Project No. 0673-002-02
Document No. 02-0296

**SUBJECT: ADDENDUM TO GEOTECHNICAL INVESTIGATION
Geothermal Power Plant, Salton Sea Unit No. 6
Calipatria, California**

Reference: Geotechnics Incorporated (2002). *Geotechnical Investigation, Geothermal Power Plant, Salton Sea Unit No. 6, Calipatria, California*, Project No. 0673-002-00, Document No. 02-0022, dated February 5.

REVISED SITE CONFIGURATION

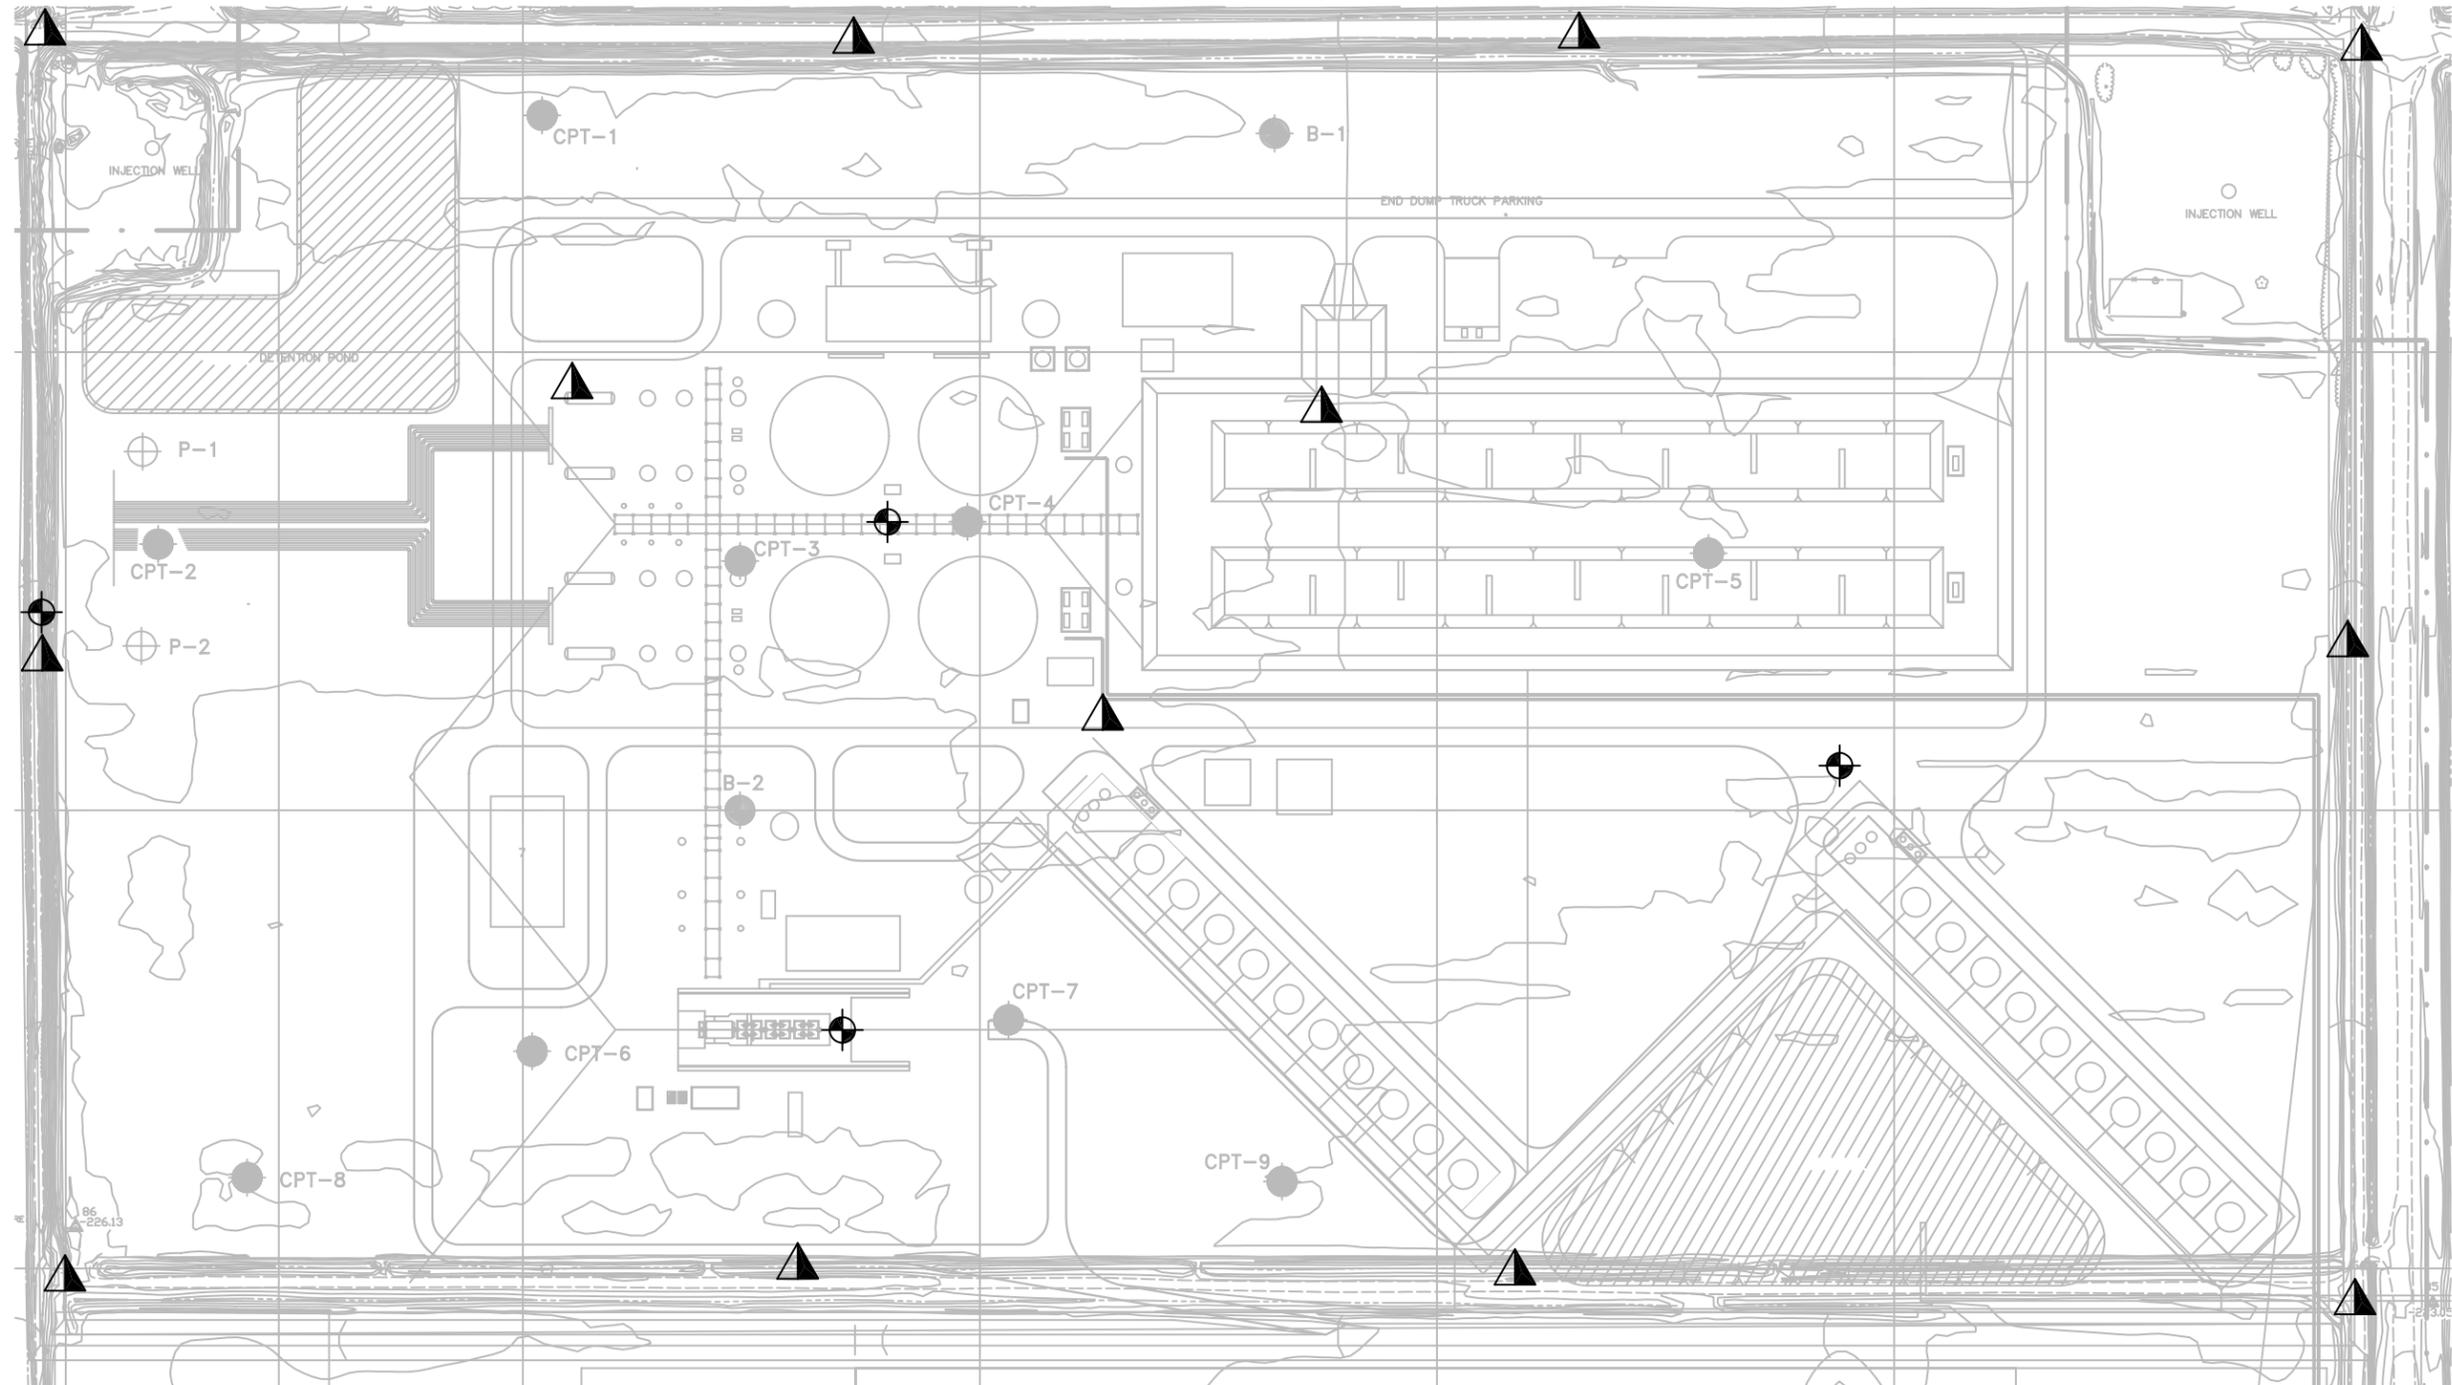
The site location and general site conditions were described in Section 3.0 of the referenced geotechnical report. The revised site configuration is presented on the attached Geotechnical Site Plan, Figure 1. The locations of the northern, western, and southern edges of the site have not changed significantly. However, the eastern edge of the site has been extended approximately 600 feet further to the east. In our opinion, the site conditions described in the referenced report remain applicable to the revised site configuration. However, additional information should be collected to confirm the subsurface conditions in the eastern portion of the site and beneath the existing and proposed embankments which form the site perimeter (see the Supplemental Investigation section of this document for more information).

The originally proposed power plant structures and improvements were described in Section 4.0 of the referenced report, and were presented on the Site Plan (Figure 2 of that document) along with the locations of the cone penetrometer (CPT) soundings and hollow stem borings conducted for that investigation. The attached Geotechnical Site Plan (Figure 1) also shows the locations of the previous CPT soundings and hollow stem borings, along with the revised power plant configuration. A comparison of the referenced Site Plan and the attached Geotechnical Site Plan shows several changes to the plant configuration. These changes are described below.

The turbine generator has been moved approximately 500 feet to the south, from the location of CPT-3 to its new location between CPT soundings 6 and 7. The clarifiers, scrubbers and demister that were originally situated between CPT soundings 6 and 7 have been moved north to the previous location of the turbine generator. Two additional clarifier tanks have been added. The cooling tower and rain water runoff basin complex that was originally located along the northern edge of the site has been moved to the southeast corner of the site. The two brine ponds that were originally located near the southwest corner of the site have been moved towards the north-central portion of the site (in the area of CPT-5). It is our understanding that up to 8 feet of fill will be added to the area of the new brine ponds in order to keep them above the anticipated groundwater table. The substation has been moved to the southeast, from the location of CPT-2 to its new location south of CPT soundings 6 and 7. Earthen embankments have been added on the southern and eastern edges of the site in order to completely surround the proposed structures and improvements, and reduce the potential for flooding of the site.

Although the general geologic framework of the site remains unchanged, the modifications to the power plant configuration have resulted in changes to the specific subsurface conditions under most of the structures. For example, the turbine generator has been placed in an area where relatively thick deposits of dense, nonliquefiable sand were observed at depth (between CPT soundings 6 and 7). The soils beneath the revised generator location may now be easier to improve than at the former location in order to attain the desired settlement tolerances. On the other hand, the clarifier tanks will now be underlain by soils that are more variable and potentially more compressible than at their former location. The addition of 8 feet of fill at the revised brine pond locations will result in areal settlement which should be estimated. Because the ponds will now be situated above the groundwater table, the use of anchor piles may no longer be necessary. The depth to groundwater at the revised location of the rainwater runoff pond should be updated and re-measured. The results of the resistivity survey conducted at the previous substation location may not be applicable at the location of the revised substation. The geotechnical impact of each of these changes should be addressed through additional subsurface investigation and/or engineering analysis, as described in the Supplemental Investigation section of this addendum.

In Section 6.5 of the referenced geotechnical report, we noted that evaluation of the stability of the existing earthen embankments along the northern and western edges of the site was outside of the scope of services provided for that investigation. In Section 6.6, we noted that failures of these slopes could result in flooding of the subject site. It is our understanding that the existing and proposed earthen embankments which will surround the site are intended to protect the site from flooding hazards. Consequently, these slopes should be designed to have an acceptable safety factor with respect to static and seismic slope failure. Therefore, the supplemental investigation of the site should include exploratory borings and CPT soundings in the area of the existing and proposed embankments, so that slope stability analyses may be conducted. The approximate locations of the proposed borings and soundings are shown on the Geotechnical Site Plan, Figure 1.

We recommend that additional subsurface investigation and engineering analysis be conducted at the site in order to analyze the stability of the existing and proposed slopes, and to update the geotechnical recommendations for the specific locations of the proposed improvements. We propose that additional hollow stem borings be conducted in the area of the settlement sensitive

turbine generator and clarifer tanks, as well as beneath the brine ponds, in order to obtain additional laboratory test data to re-evaluate the settlement potential. We propose to conduct additional CPT soundings in the revised area of the clarifiers to evaluate the thickness and extent of the liquefiable and non-liquefiable sands in that area. Additional CPT soundings and hollow stem borings should also be conducted in the area of the existing and proposed earthen embankments to aid in slope stability analyses. We should also construct a monitoring well in the area of the rain water runoff pond in order to provide an updated estimate of groundwater levels in that area. We also recommend that an additional resistivity survey be conducted in the area of the substation to provide data for grounding design at the new location. The approximate locations of the proposed borings and CPT soundings are presented on the Geotechnical Site Plate, Figure 1.
